Subject: Midterm Completion Response, Canyon Fuel Company, LLC, Banning Siding Loadout, C/007/034, Task ID# 5188

Title: Completion of Midterm Review Response, Banning Loadout, C/007/034, Task ID #5188

Subject: Completion of Midterm Review, Task ID # 5078, Canyon Fuel Company, LLC, Banning Siding Loadout, C/007/0034

PID: C0070034
TaskID: 5188
Mine Name: BANNING SIDING LOADOUT
Title: MIDTERM COMPLETION RESPONSE

Banning M&RP, Exhibit 5-6A

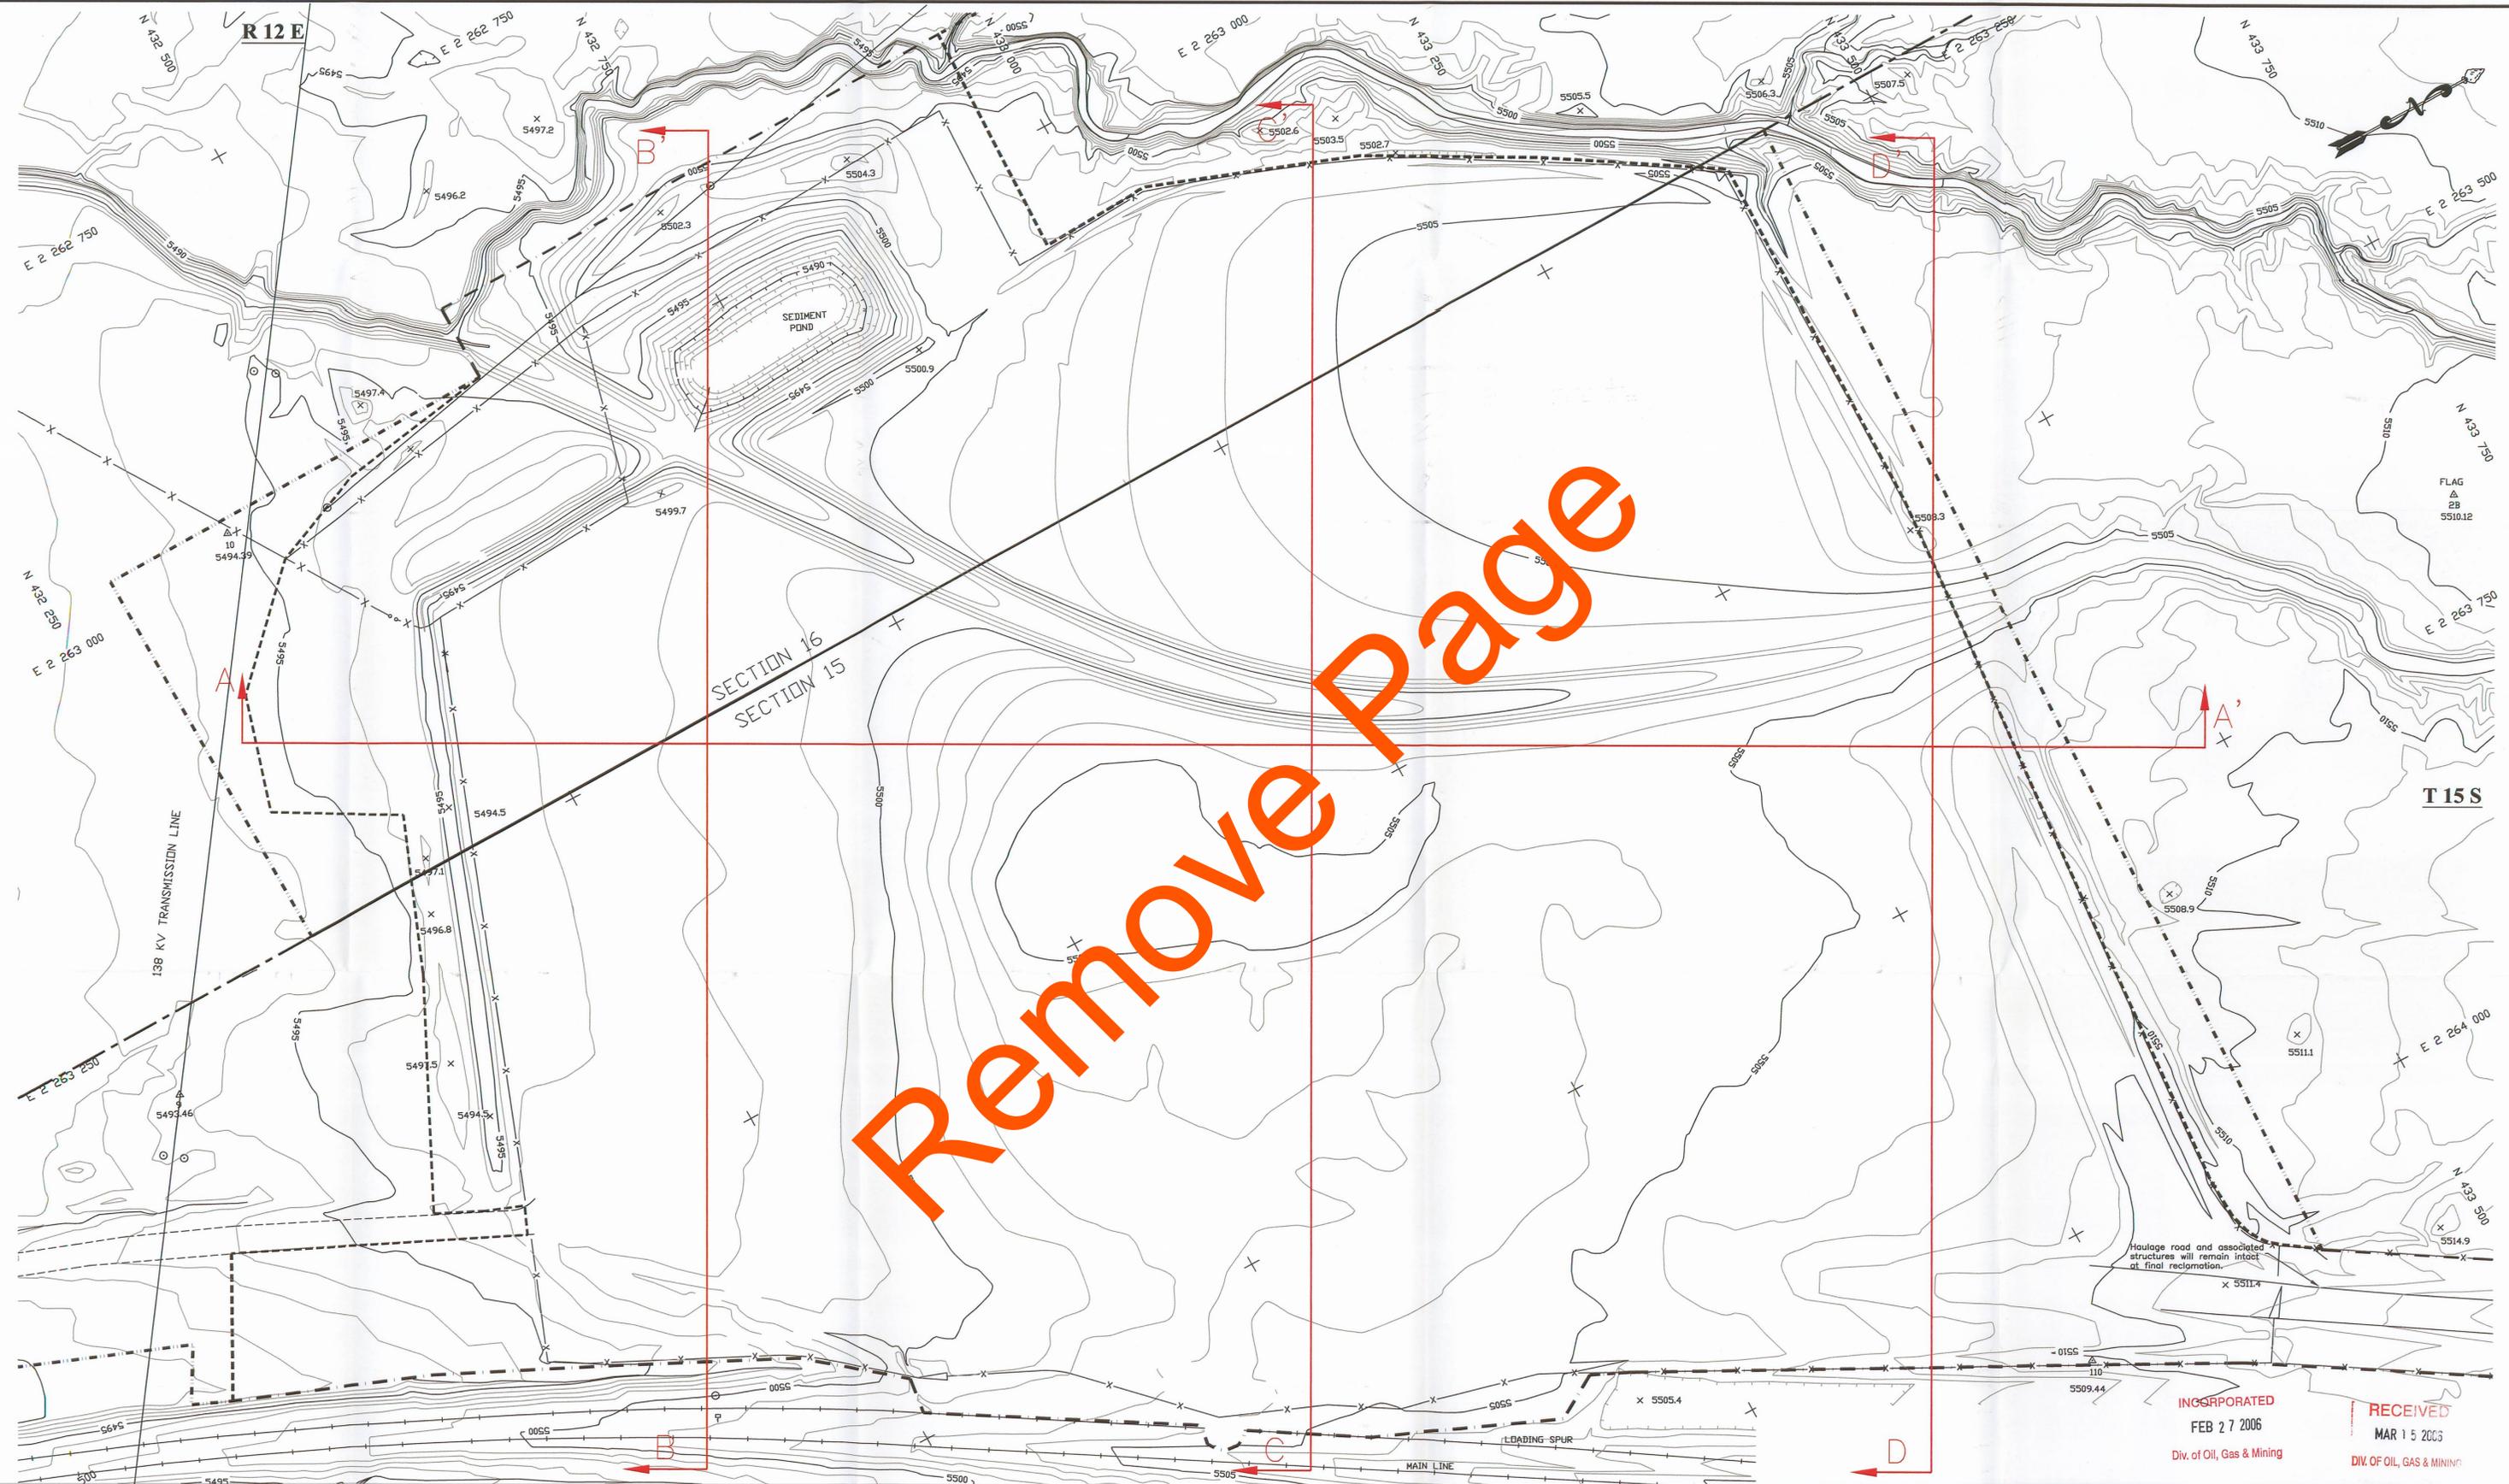
R645-301-121.200: The Permittee will amend the narrative to clarify that the substation has been approved for a change in post mining land use and is no longer under the Permittee's obligation to reclaim in Chapter 5 page 5-27 and add narrative describing the haul road and tracks that will also remain post reclamation of the loadout area.

R645-301-212.200, R645-301-542: The Permittee will amend all relevant Chapter 5 sections of the MRP to reference reclamation scenario Exhibit 5-6a.

Response: Chapter 5, page 5-27 was modified to remove the substation and clarify the narrative describing the haul road and tracks post reclamation. Exhibit 5-6A was removed from the M&RP.

Response: Exhibit 5-6a was removed from the M&RP. All references will be to Exhibit 5-6 as the substation will remain after final reclamation disregarding Exhibit 5-6a. Chapter 5, Section R645-301-512.130, page 5-2 text 5-6A was removed. Chapter 5, Section R645-301-512.260, page 5-4 text 5-6A was removed. Chapter 5, Section R645-301-541, page 5-44 text 5-6A was removed. Chapter 5, Section R634-301-542.200, page 5-47 text 5-6A was removed. Chapter 5, Section R634-301-542.200 & Section R645-301-542.300, page 5-48 text 5-6A was removed. Chapter 5 Section R645-301-552, page 5-52 text was changed from 5-6A to 5-6.

Banning M&RP, Exhibit 5-7A Added
Banning Loadout, Permit Number C/007/034

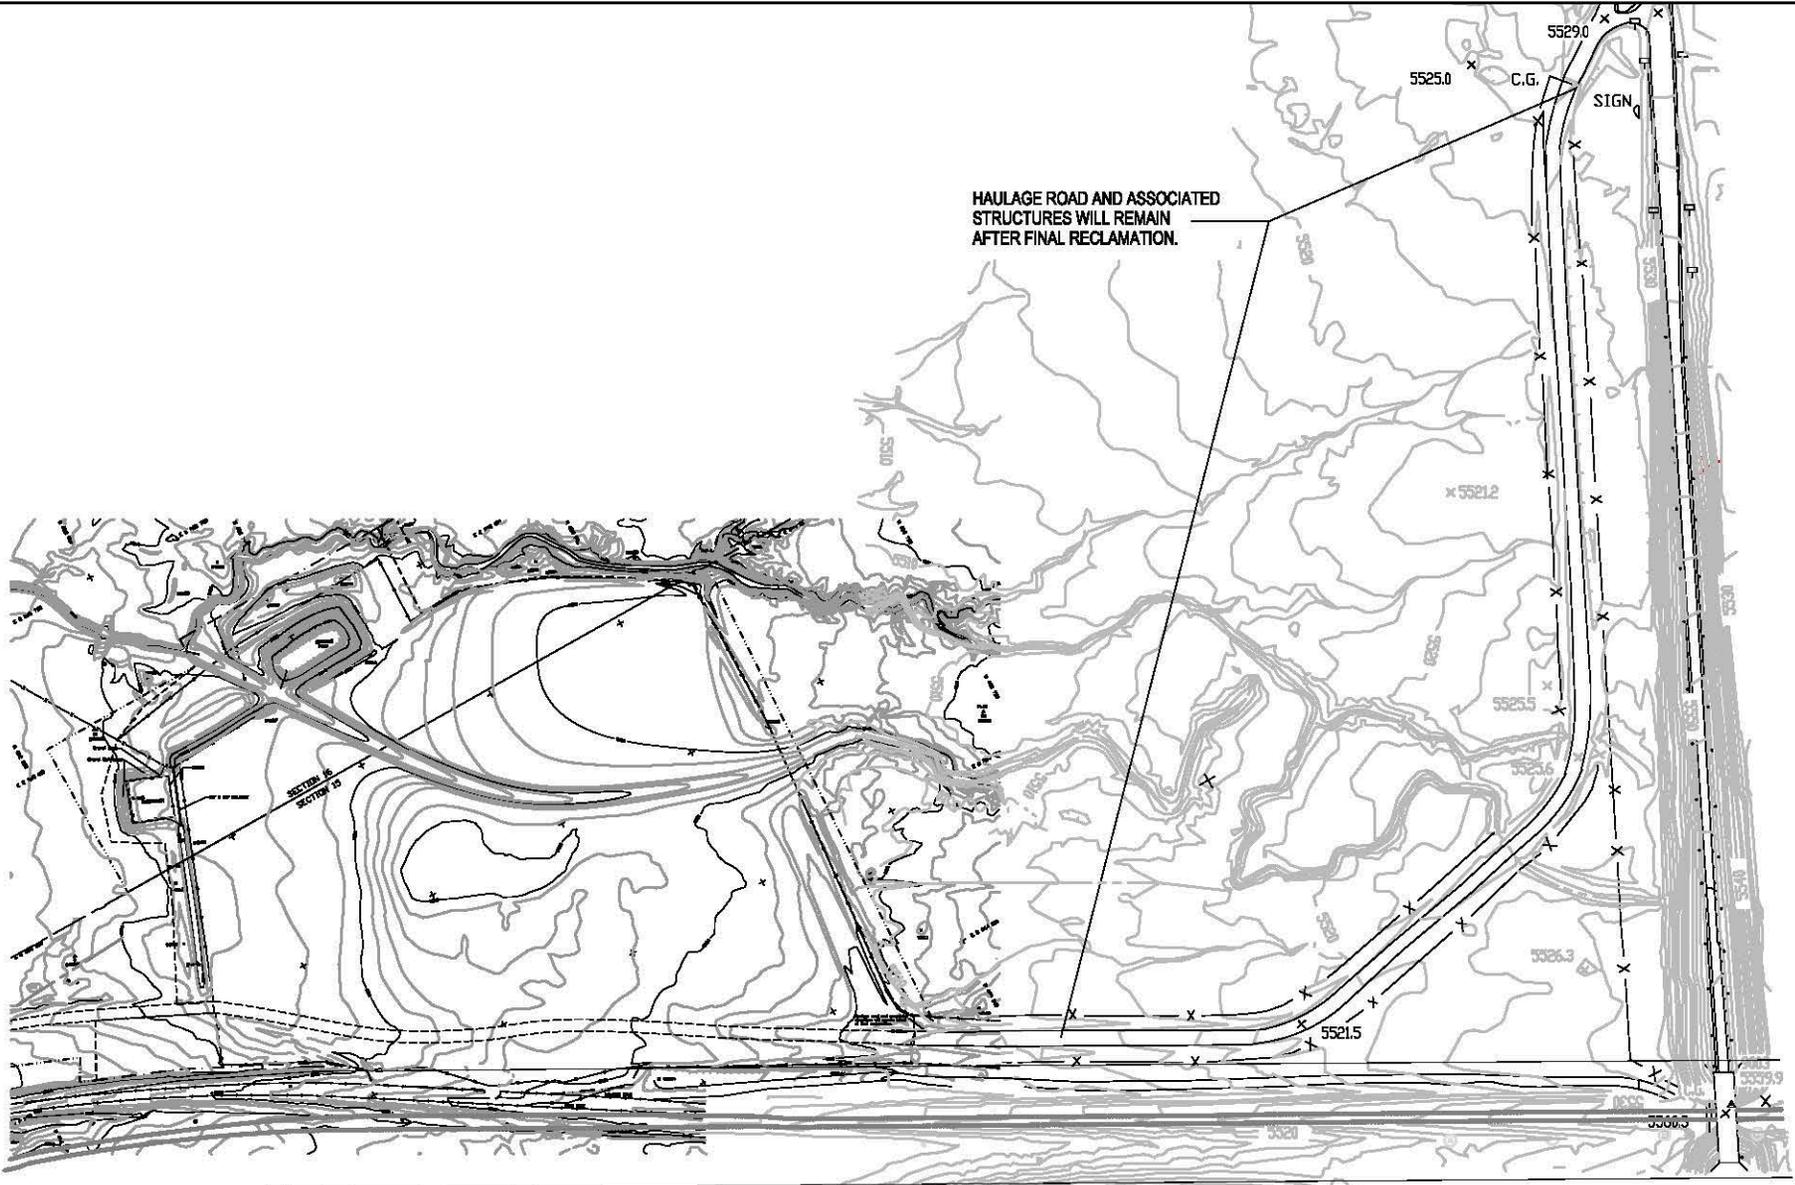
R645-301-534: The Permittee will amend the narrative of Chapter 5 Section R645-301 -534.100 to clarify what portions of the operational roadways will remain post reclamation of the site.

Response: Chapter 5, Section R645-301-526.100, pg 5-27 the text is revised to clarify what portions for the haul road remain after reclamation. Exhibit 5-7A was also added to help clarify the haul road after reclamation.
